REMARKS

Application No. 10/580,289
Amendment dated May 10, 2010
After Final Office Action of December 14, 2009

Docket No.: 66599-0005

FIG. 4

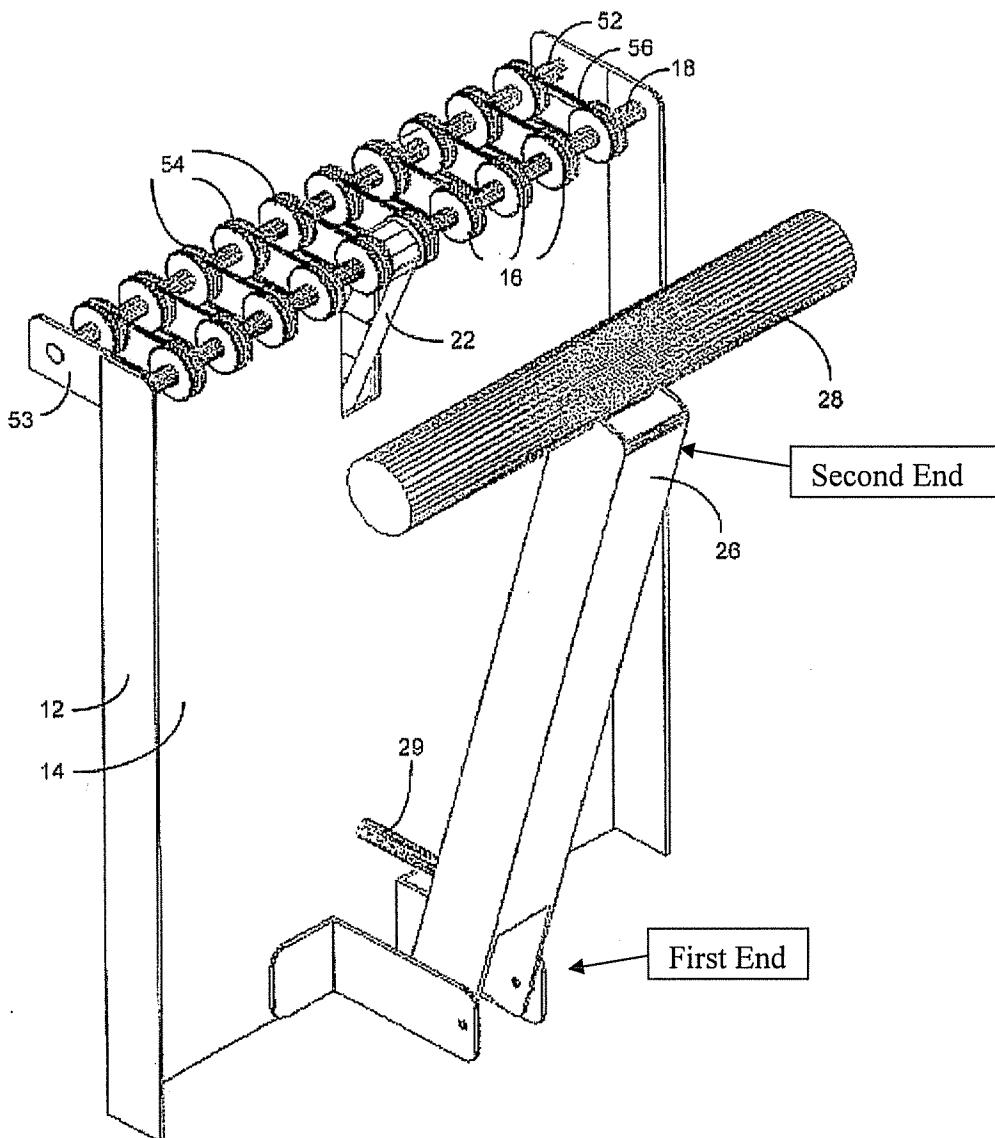
The drawings were objected to under 37 CFR 1.83(a). More specifically, the examiner objected to the drawings, alleging that the “first and second end” recited in new claims 26-28 were not shown in the drawing figures. Applicants respectfully disagree.

The Examiner also rejected claims 26, 27 and 28 under 35 U.S.C. § 112, ¶ 2 for allegedly being indefinite for failing to particularly point out and distinctly claim the subject matter which applicant regards as the invention. More specifically, the Examiner suggested that the specification does not adequately describe the “first and second ends” of the retaining element. Applicants respectfully disagree.

FIG. 4, for example (reproduced below for the Examiner’s convenience) clearly shows an embodiment of the bag dispensing device that includes a bag-retaining arm 26. As may be seen, the bag-retaining arm 26 has a first end and a second end. The first end of the bag retaining arm 26 is pivotally connected to the rear surface of the plate 14. Thus, the drawings do, in fact, illustrate the “first and second end” features set forth in claim 26. Accordingly, Applicants respectfully request that the objection be withdrawn.

As set forth above, FIG. 4 illustrates an embodiment of the retaining element, i.e., a bag-retaining arm 26. The bag retaining arm 26 is clearly shown with a first end pivotally connected to the rear of surface of plate 14 and a second end connected to a bar 28. Indeed, paragraph [0036] specifically describes that the bag-retaining arm 26 is pivotally mounting on a rear surface of plate 14. Further, paragraph [0036] also states that “a bar 28 is mounted on the end of arm 26...” Thus, one of ordinary skill in the art reading the specification in connection with the drawings would understand that one end of the retaining element, i.e., a first end, is pivotally connected to the plate and could clearly distinguish a second end of the retaining element. Accordingly, withdrawal of the rejection is respectfully requested.
